Docket Item # 12
BAR CASE #2009-0208

BAR Meeting
October 7, 2009

ISSUE: Alterations
APPLICANT: Jerry and Sara Kilkenny
LOCATION: 500 North Columbus Street
ZONE: CL/ Commercial Low Zone

Figure 7: Proposal – Oronoco Street Elevation (new French Door Installation)

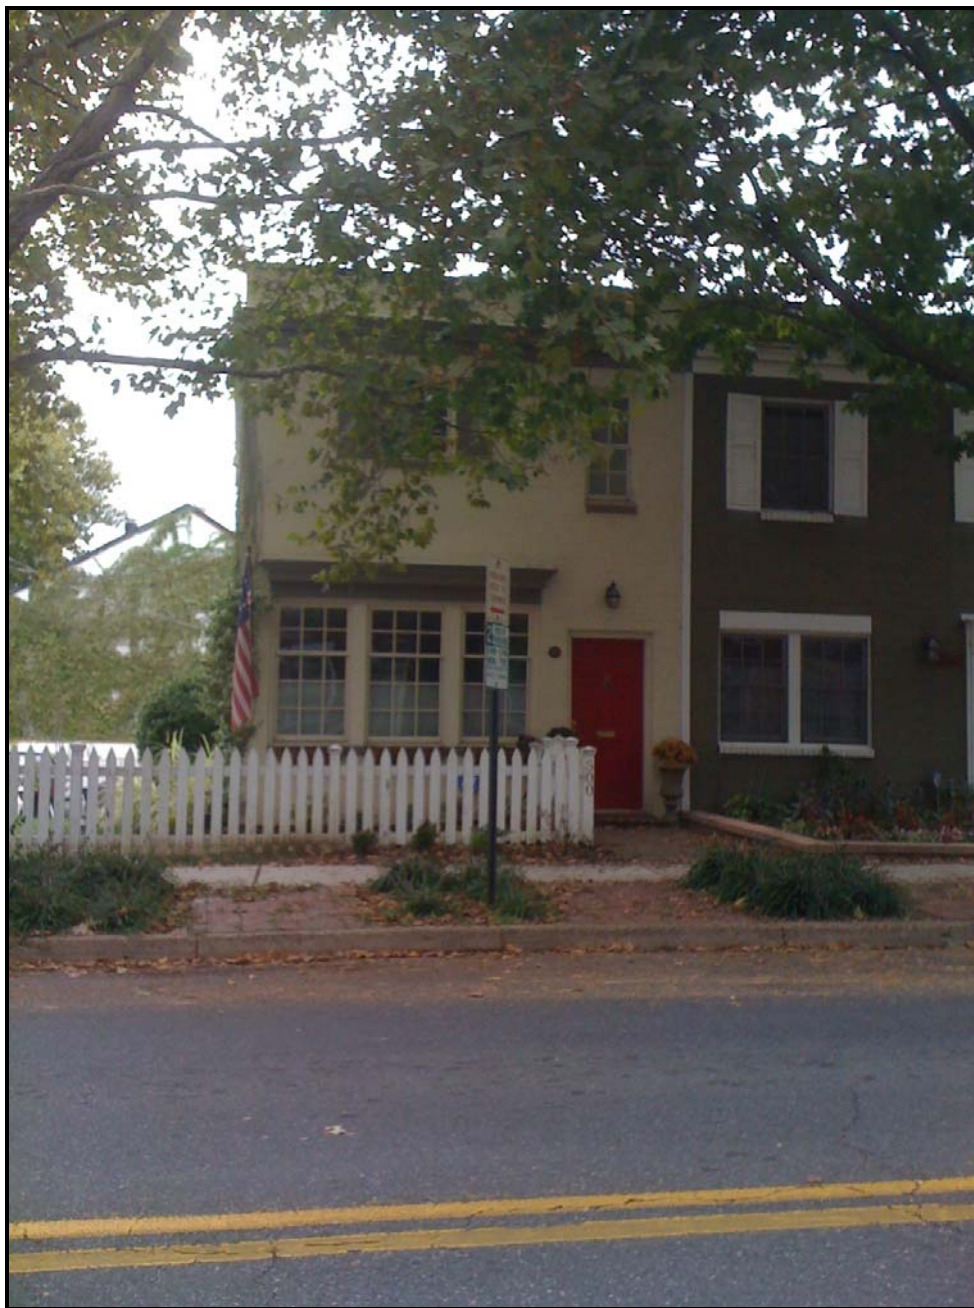
Staff finds that the width and design of the proposed, new door incompatible with and disproportional to the existing fenestrations on the south elevation. As this elevation is secondary to the principal façade, any new punctures should be compatible with the original architectural style of the building, while being subordinate. As such, it is recommended that the door’s width be aligned with the window above, and detailed to match the existing rear entry door, a half glass, nine-light, two paneled wood door.

1. That the new door to be installed on the Oronoco Street elevation will be a nine-light, half-glass wood door, with two raised lower panels to match the existing rear door.
2. That the rear door will be retained in place and the opening not closed.

Figure 9: Proposal - Rear Elevation (Door Removal/Brick Enclosure)

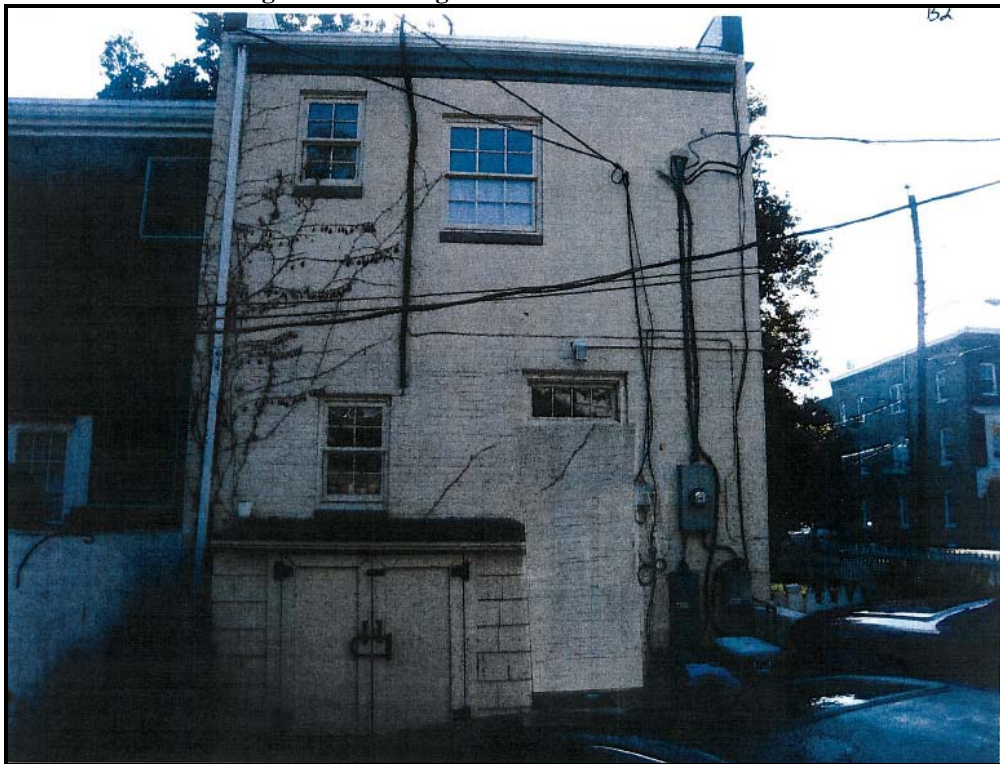
Additionally, Staff generally does not support the removal of original building fabric, as the philosophy of historic preservation is to retain original building materials and features. Therefore, Staff objects to the removal of the door on the rear elevation. Additionally, altering this façade will remove this elevation’s only entry door and forever change the hierarchy of this building’s elevations. However, if the Board finds that they support the removal of the door on this elevation, it is recommended that they require differentiation by recessing the new brick wall a minimum of one inch from the existing wall surface. Alternatively, if the Board desires to retain a portion of the opening in this location, Staff recommends the installation of a 6/6 double-hung simulated-divided light wood window with a lower raised wood panel. This design detail is typical for this era of homes and architectural style. One can see several examples of this detail throughout the historic district on homes of the same construction vintage.

3. That the rear door opening is enclosed with a 6/6, wood simulated divided light double-hung window and lower raised wood panel.

4. That the brick being utilized to fill in the rear door’s opening be recessed a minimum of one inch from the existing wall surface.

Figure 10: Examples of Proposed Lattice with Plant covering to be installed in front of newly, enclosed rear door

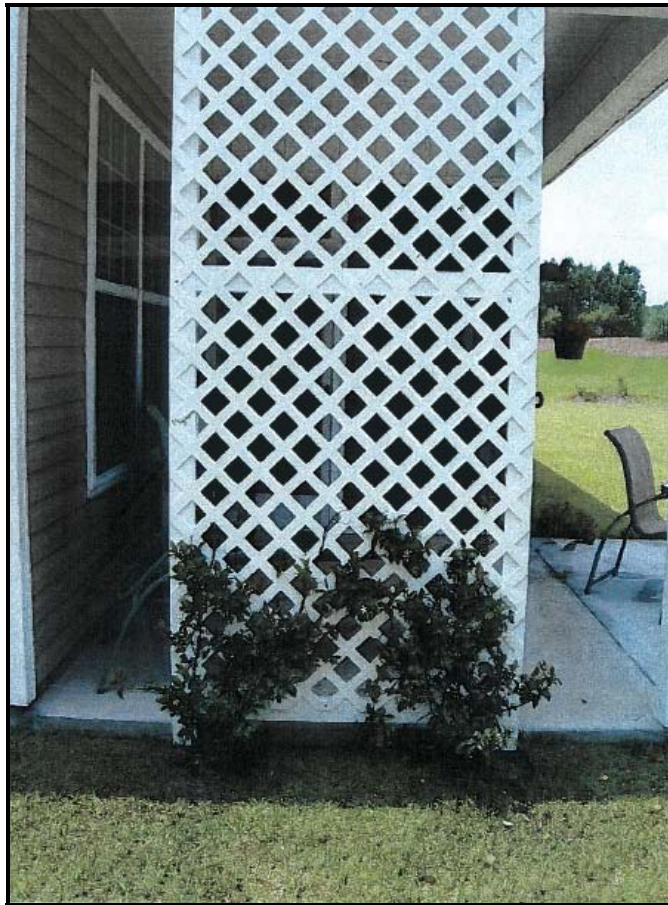
The *Design Guidelines* also identify “mass produced wood diagonal lattice” as not appropriate within the historic district, and specifies that “wood lattice should have a rectangular pattern rather than a diamond pattern.”

5. That the proposed lattice trellis is fabricated from horizontal and vertical wood boards surrounded by a wood frame, rather than diagonal lattice as proposed.
6. That the proposed lattice trellis will be installed to disguise the door opening as well as the existing electrical meters located on the rear elevation.
7. The proposed lattice trellis will be free-standing.
